Awel y Môr Offshore Wind Farm

Application Errata List

Deadline 1

Document Reference: 1.4

FIGURE NUMBER:
Figure 19

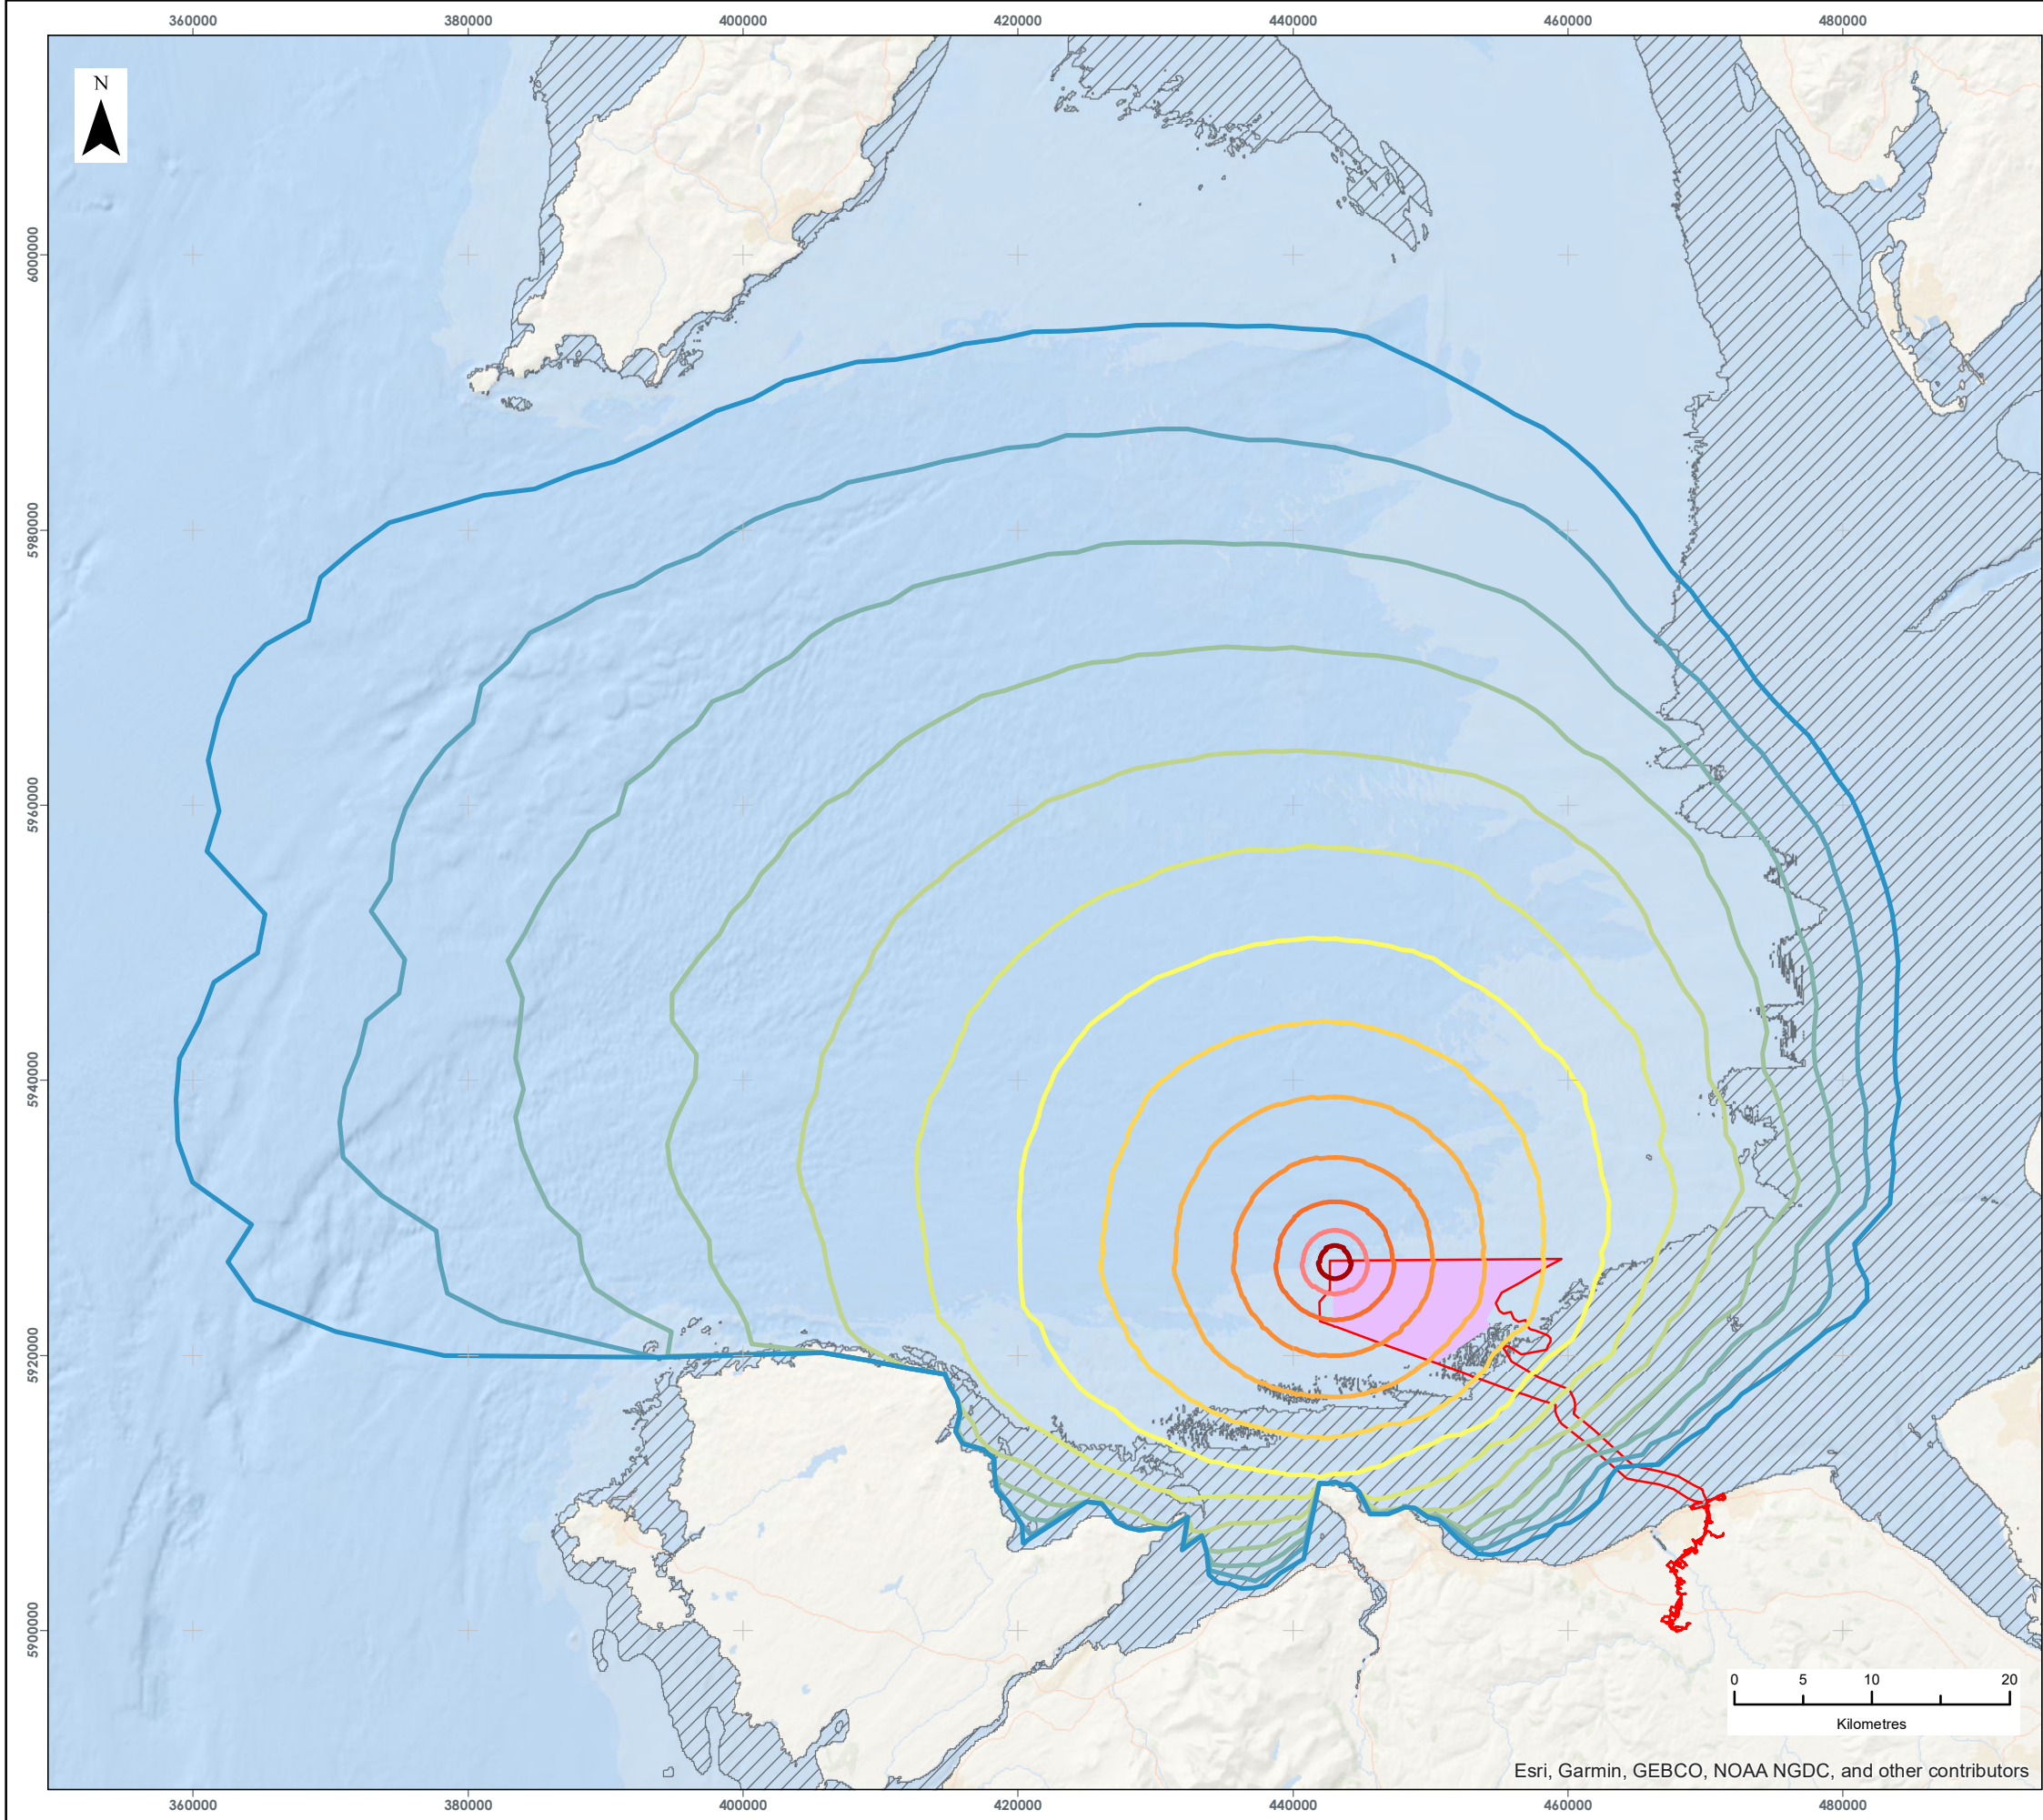
- ▲ Figure 19: Figure missing from AS-026 with Figure 21 incorrectly presented in its place. Corrected figure provided in Appendix A of this document. Note this figure is identical to Figure 19 presented in APP-053.

FIGURE NUMBER:
Figure 21

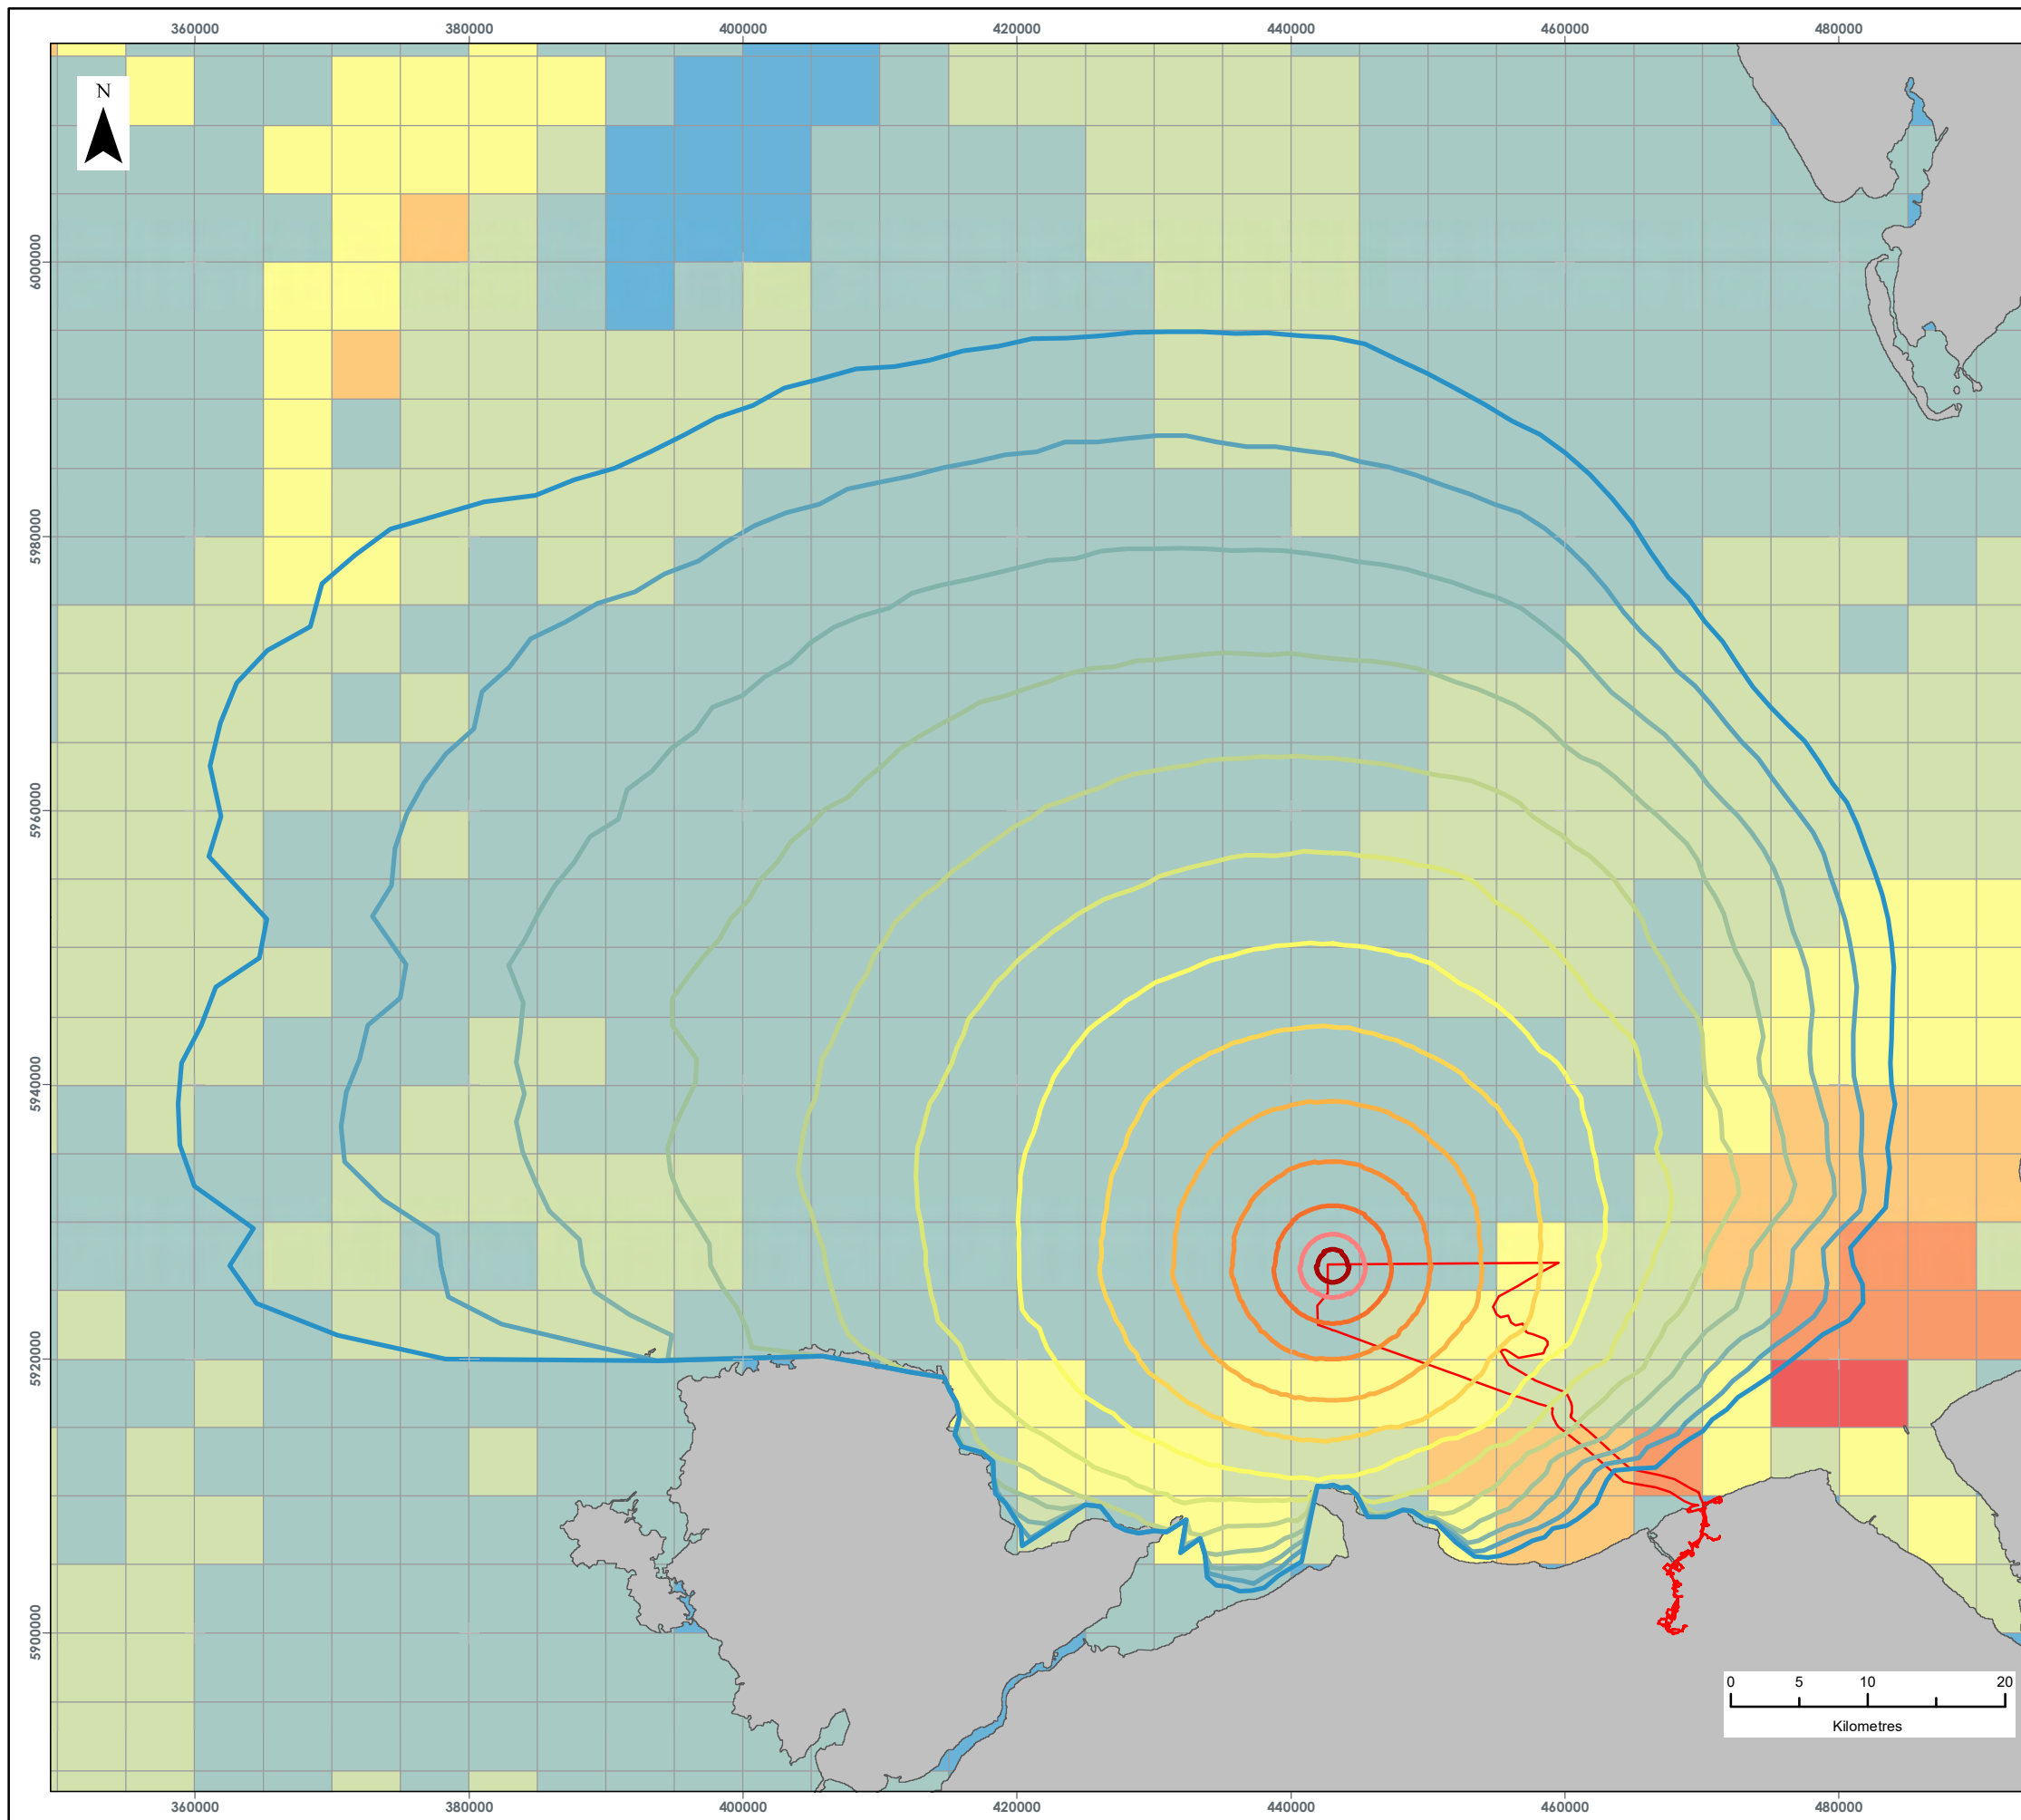
- ▲ Figure 21: Figure incorrectly displayed a partial black background and omitted base mapping. Figure was incorrectly presented in place of Figure 18. Corrected figure provided in Appendix A of this document. Note this figure is identical to Figure 21 presented in APP-053.
